PARTS & SERVICE NEWS

REF NO. AA01079

SUBJECT: ADD SPACER TO ENGINE WIRING HARNESS**PURPOSE:** To correct Bill of Material.**APPLICATION:** WA180-3L Wheel Loader Serial Number A80001 and UP
WA180-3PTC Wheel Loader Serial Number A85001 and UP
WA250-3L Wheel Loader Serial Number A70001 and UP
WA250-3PTC Wheel Loader Serial Number A75001 and UP**FAILURE CODE:** D520PP**DESCRIPTION:**

VLPB1572

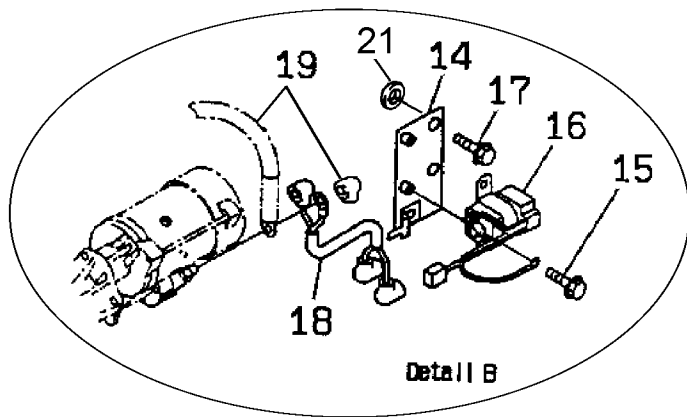
Spacer part number 6202-83-6560 was omitted from the original Bill of Material and applicable Parts Books.

1	600-815-2170	SWITCH	1
2	01435-00610	BOLT	2
3	417-06-A1580	ENGINE WIRING HARNESS	1
4	426-01-12360	PLATE	1
5	01435-01016	BOLT	1
6	08036-01814	CLIP	6
7	08036-01214	CLIP	1
8	01435-01016	BOLT	3
9	01435-01220	BOLT	2
10	08036-00814	CLIP	1
11	08036-10814	CLIP	1
12	08053-00912	CLIP	1
13	01435-01220	BOLT	1
14	1308 344 H1	BRACKET	1
15	01435-01220	BOLT	2
16	1207 387 H2	SWITCH	1
17	01435-00516	BOLT	2
18	1308 349 H91	WIRE	1
19		BATTERY RELAY AND STARTER HARNESS	1
20		TRANSMISSION HARNESS	1
21	6202-83-6560	SPACER	2
